Please Note:

It has been necessary to change the height and format of the roof. The height of the building has grown to approx 2.75m. The planning drawing indicated 2.5m.

Side Elevation - Facing Garage

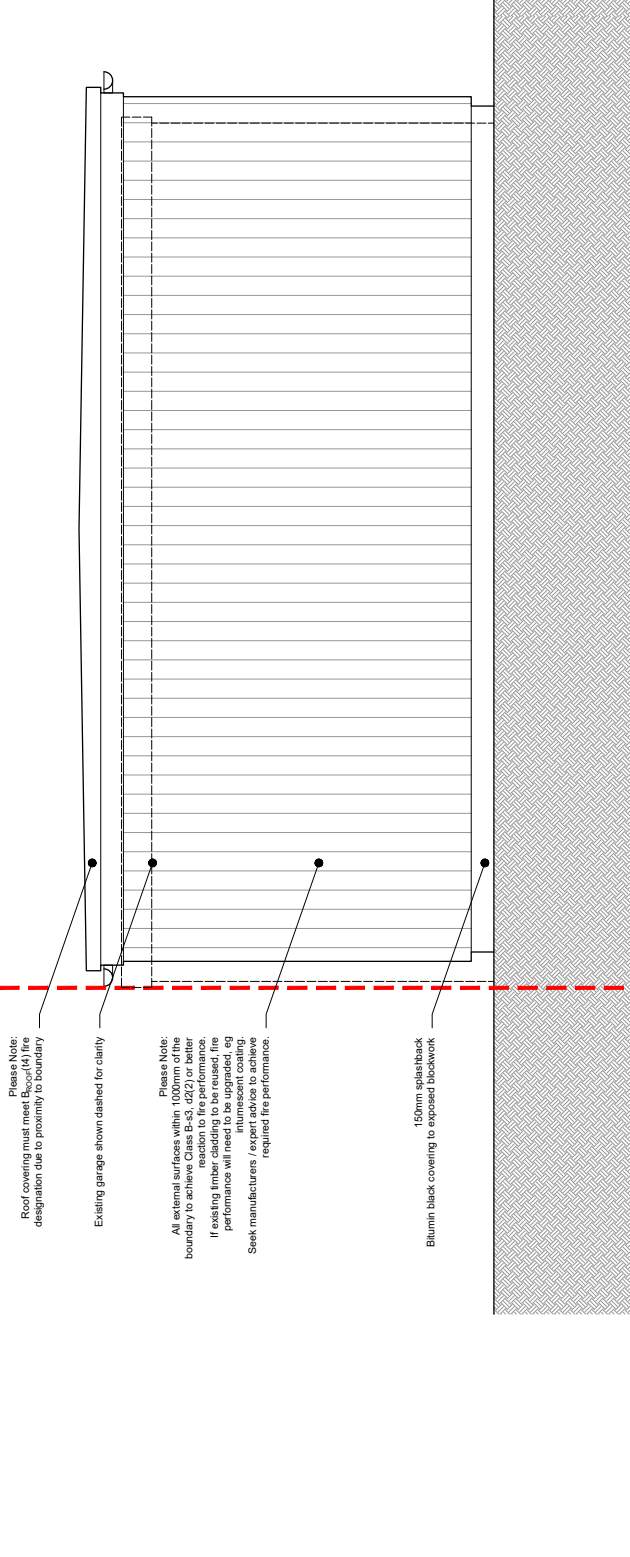
The parapet has been removed and external gutters substituted. This is because the heights and construction shown were not achievable.
